METHOD STATEMENT TITLE	Rev. B
Method Statement for Installation of Sheet Piles for the Temporary Underfloor Wheel Lathe

Document Title: Method Statement for Excavation and Lateral Support for the Temporary Underfloor Wheel Lathe
Document Revision: 22-Feb-24
Deadline: 09-Apr-24

Figure 7.7.1: Installation of Sheet Pile Stage from Phase 1 to Phase 4 indicated in figure above. The green lines identified the 10m area from the adjacent OHL or live track

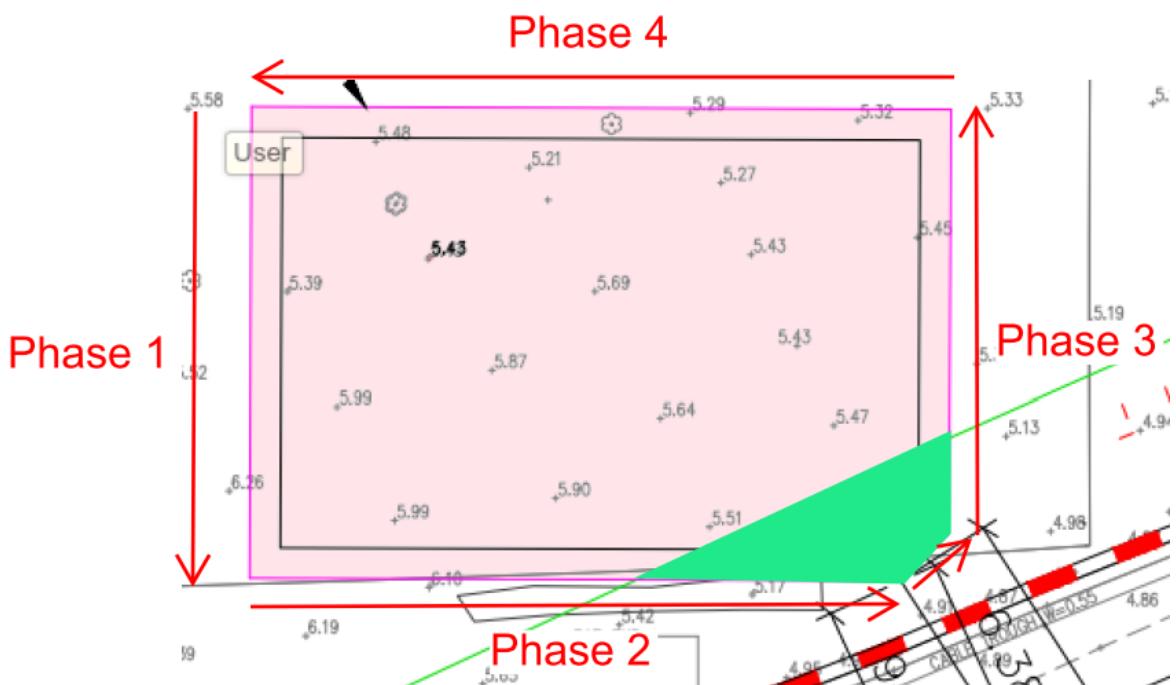
<p>Pls consider amending 1701 Permit-to-Dig system accordingly. Kindly clearly state the reasons why the changes are considered inapplicable otherwise.</p>	The safe distance during excavation by using machinery should be addressed on the permit to dig.	The types of machinery and excavation methods should be specified on the permit-to-dig and the allowed operation area should be demarcated on site	Appoint a designated engineer to approve the permit-to-dig. Specific training should be provided to the responsible engineer for briefing on the permit-to-dig issuance procedure.	The permit-to-dig should countersign by the designated engineer after verifying the accuracy of the permit-to-dig and the information in UU report. Work can only commence after approval from the designated engineer.	The responsible engineer should participate in the briefing for the permit-to-dig to explain the planned excavation method and sequence.	<p>Permit-to-Dig system was updated and attached in Appendix K for your reference.</p> <p>The permit to dig is issued by the Site Agent or Construction Manager. He/She is responsible to brief the Engineer for the underground utilities in the area in the Permit to Dig. The Engineer will brief the plant operators and workers in a training and sign on the Permit to Dig for record. A Chinese version method statement and layout plan will be also presented in the briefing section.</p>
The safe distance during excavation by using machinery should be addressed on the permit to dig.									
The types of machinery and excavation methods should be specified on the permit-to-dig and the allowed operation area should be demarcated on site									
Appoint a designated engineer to approve the permit-to-dig. Specific training should be provided to the responsible engineer for briefing on the permit-to-dig issuance procedure.									
The permit-to-dig should countersign by the designated engineer after verifying the accuracy of the permit-to-dig and the information in UU report. Work can only commence after approval from the designated engineer.									
The responsible engineer should participate in the briefing for the permit-to-dig to explain the planned excavation method and sequence.									
3	RP	-	Please find my comments which are marked in Red in the attached returned file. (refer to Yu Sir email)	The comments are addressed and attached in the email for your reference.					
4	RP	-	<p>Figure 7.1.1 refers, please provide a layout plan showing the clearance between the sheet pile and railway facilities to justify the extent of 5m height sheet pile.</p>	<p>The figure 7.7.1 is updated to show the minimum extend of maximum 5m height sheet pile for your reference.</p>

Figure 7.7.3: Plan view showing the Distance between the silent piling machine set up location and one of the closest OHL posts are around 29 meters.

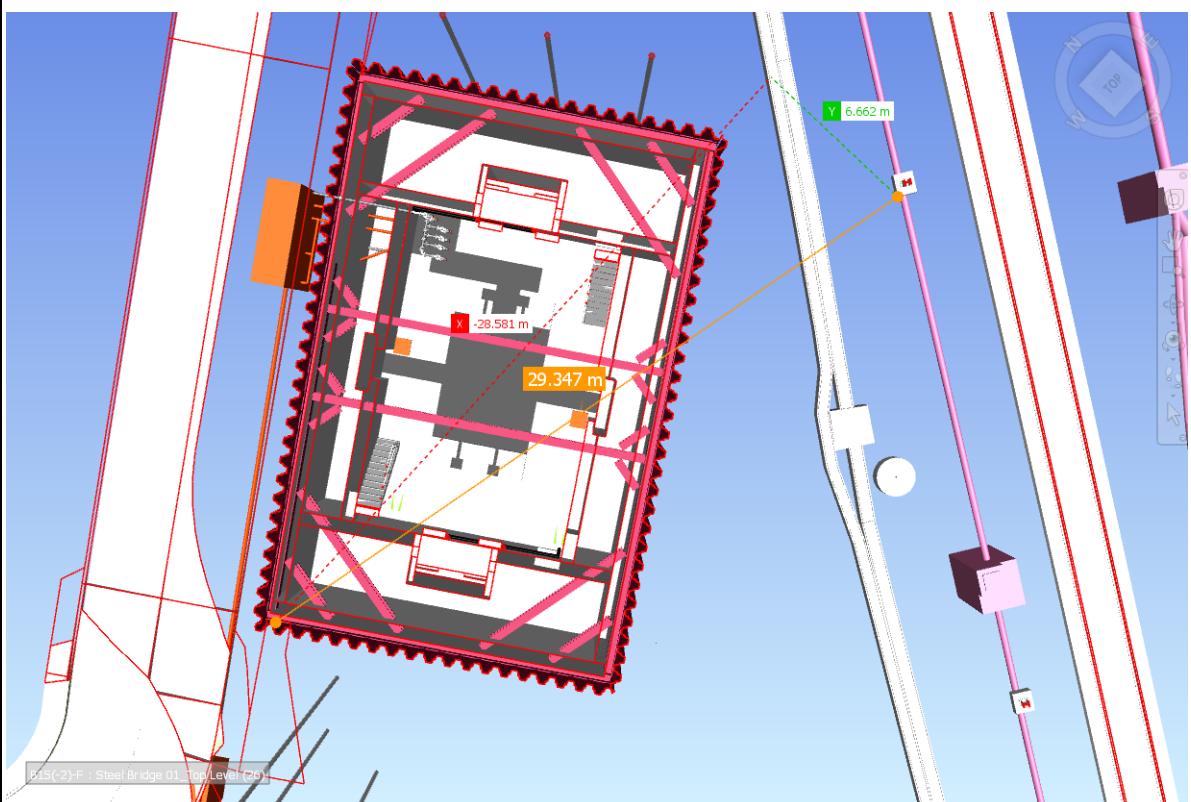
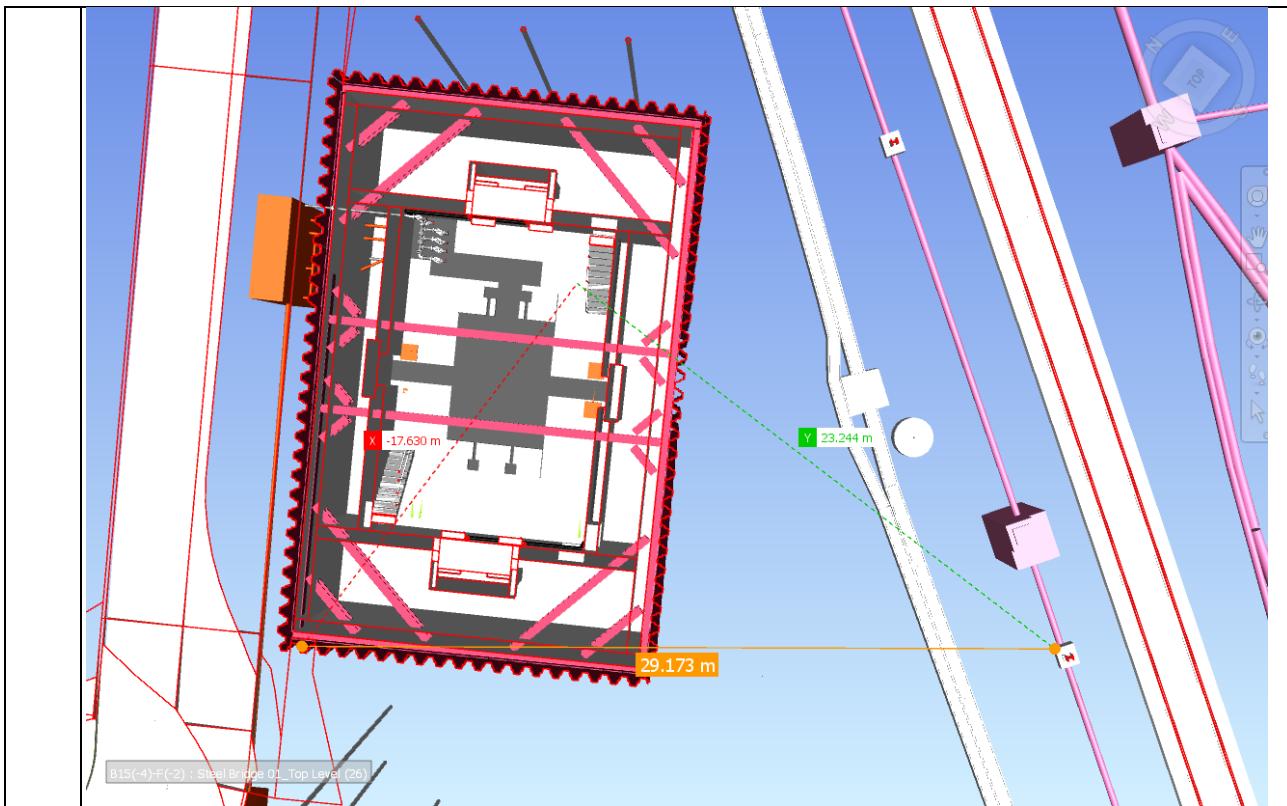
The setup location of the silent piling machine and the relationship between the railway facilities shall be considered.	The setup location is around 29m, which is a screenshot captured in the Navisworks model and attached in Figure 7.7.3 for your reference. 
5	RP	-	PA works shall be applied when the sheet pile location was 10m measure from the railway facilities.	Noted. PA works will be input in ETMS system before commencement of work within 10m from the railway facilities if necessary. This sentence also added to section 7.7 Step 3 for clarification of the works.
6	RP	-	Appendix D, proposed TUFWAL lifting plan (stage 1) refers, the operation zone for the 32T crane lorry was found intruded into the existing railway facilities which is not acceptable. The jib length shall be specified. The lifting capacity of the crane lorry shall not exceed 80% of SWL. Section showing the critical lifting works shall be provided. The collapse path of the lifting works shall not intrude to the railway facilities.	The crane lorry is replaced with a 60 ton mobile crane, with the use of 75 feet. The catalog is attached in Appendix F. The lifting plan is attached in Appendix D. A CP(T) shall be provided for the supervision works and ensure no lifting works is within the railway or OHL post area. The lifting calculation is attached below. Weight of a 12m FSP III Sheet Pile = 720kg Maximum Lifting Length is 24meter 80% lifting weight = 3920 kg Therefore using 27m 60ton Mobile Crane can fulfill the lifting requirement

39	Yu Sir	<p>1. Figure 7.7.3 & 7.7.4 on Page 24 of 47 :- The mentioned 29m distance is misleading. The closest distance between silent piling machine and the OHL Posts shall be measured from the SOP03.</p>	<p>This figure mainly responds to Rtc No.5 regarding the setup location of the silent piling machine. For the entire sheet piling installation works, the silent piling machine can handle the corner works without requiring any lifting during the installation of the corner sheet pile. Therefore, there is only one designated setup location, SOP01, which aligns with figures 7.7.3 and 7.7.4.</p>
